Clitheroe Light Engineering- new building proposals- 3/2017/1020

Phone: 0300-123-6780**Email:** Suds@lancashire.gov.uk**Date:** 13th April 2018**APPLICATION CONSULTATION RESPONSE**

Application Number:	3/2017/1020
Location:	Unit A to C Up Brooks, Clitheroe, BB7 9SE 1 PL
Grid Ref:	E 375182, N 442128
Proposal:	Proposed new production unit

Table 11.1
Permeability and Drainage Characteristics of Soils*

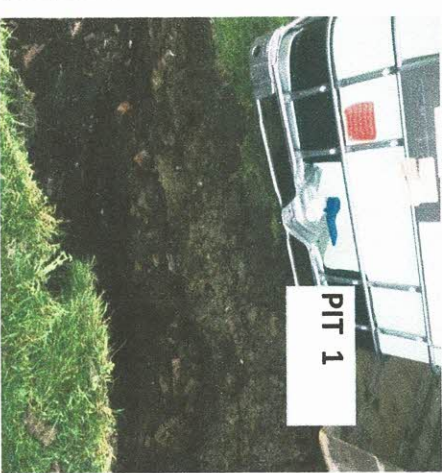
The drainage hierarchy (1) of soakaway, watercourse, drainage system has been followed and the percolation test results (2) show ground with limited soakage. New surface water runoff will connect to United Utilities public surface water manhole 1105 and an exceedance diagram is attached (3) showing runoff routes over the roads into Mearley Brook. In terms of sustainable drainage calculations the BRE 365 procedure spreadsheet shows that a 20m length soakaway 0.8m sidewall depth can cope with 2.76m3 of runoff in 24 hours. A site for a soakaway is to the west of the new building and as soakage is limited the cellular crate surface water storage of 25m3 will be placed here to at least soak some runoff into the ground as well as provide storage. Flow calculations are new hard area 1000m2 x 0.014 l/sec/m2 for a 1 in 2 year storm (Building Regs Approved document H) giving 14 l/sec, a 1 in 30 year runoff rate is 14 x 1.9 growth factor = 27 l/sec, 1 in 100 year runoff rate 14 x 2.5 GF = 35 l/sec, 1 in 100 year + 30% CC= 45.5 l/sec. (4). The HR Wallingford printout shows the storage volume. Post consent, detailed Microdrainage calculations and contract drawings showing drainage, slab levels, and road levels will be prepared for Building Regulations submission.
